Address: **396-402 SYDNEY ROAD, BALGOWLAH**

Project: **PROPOSED MIXED-USE BUILDING**

Report: **ACCESSIBILITY REPORT FOR DA SUBMISSION**

Reference: 200096 – Access Report

FIGURE 2.2 EXAMPLE OF AN ANGLE PARKING SPACE WITH SHARED AREA ON ONE SIDE ONLY—DIMENSIONS FOR AUSTRALIA ONLY*

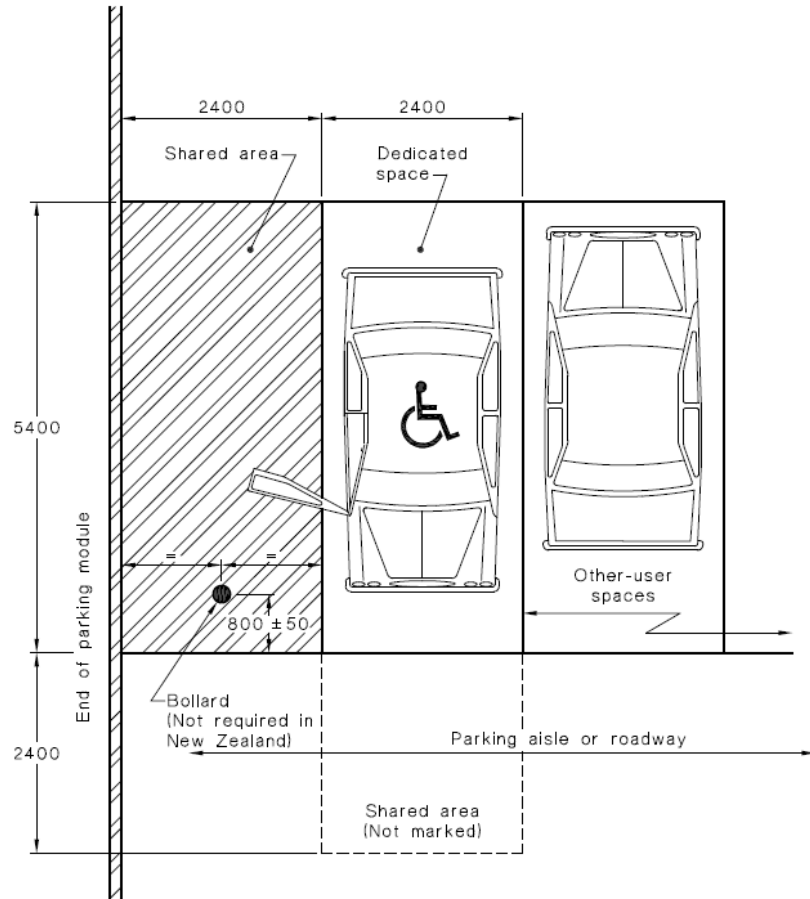
12. Accessible car spaces will achieve compliant headroom clearances in accordance with Clause 2.4 of AS/NZS 2890.6-2009.
13. Bollards will be provided in the shared disabled car space area in accordance with Clause 2.2.1(e) of AS/NZS 2890.6-2009. Refer to Annexure B1 for a diagrammatic explanation.
